Project: 424C01 Cornish Library & Community Center
226 NH-120
Cornish Flat, New Hampshire 03746

RFI #23: Reroute of Water Line

Subject: Domestic water pipe reroute

Plan: P-2 NEW - Plumbing Basement Plan

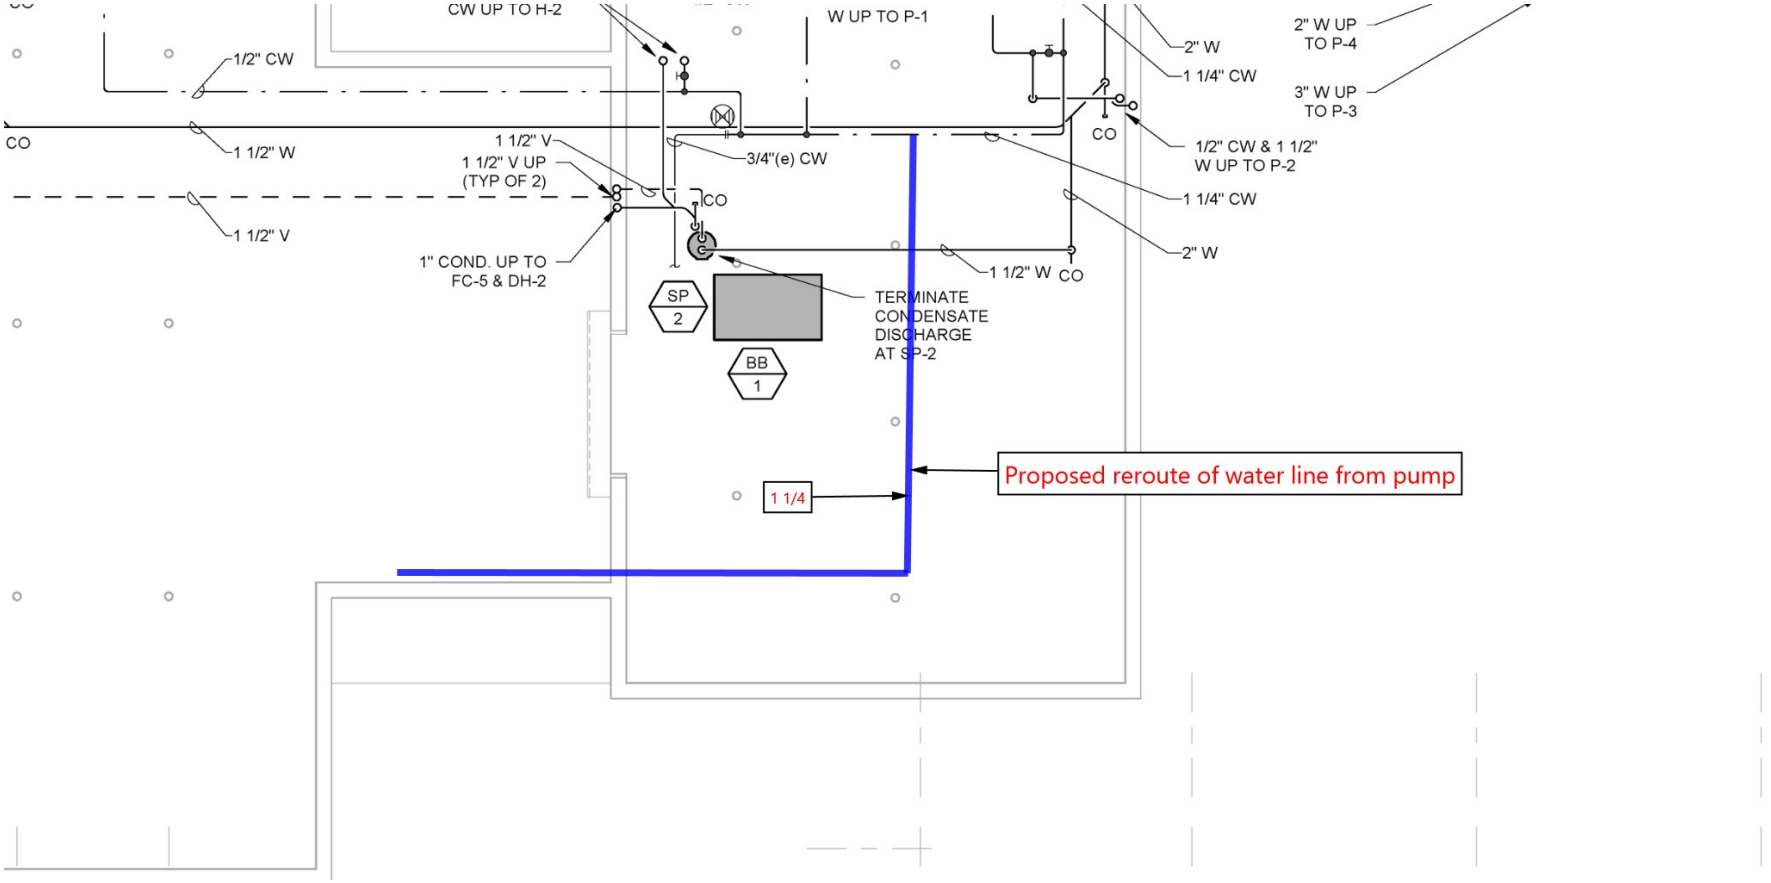
Please see attached documents from Merrill. Richard, this reflects our discussion in the field regarding the water line and tank relocation.

Request: Relocate domestic water main, expansion tank and pump controls. Due to a conflict with the drainage from the sump pump.

- No exceptions taken to the contractor's proposed relocation. Coordinate any associated electrical work with the electrical contractor.
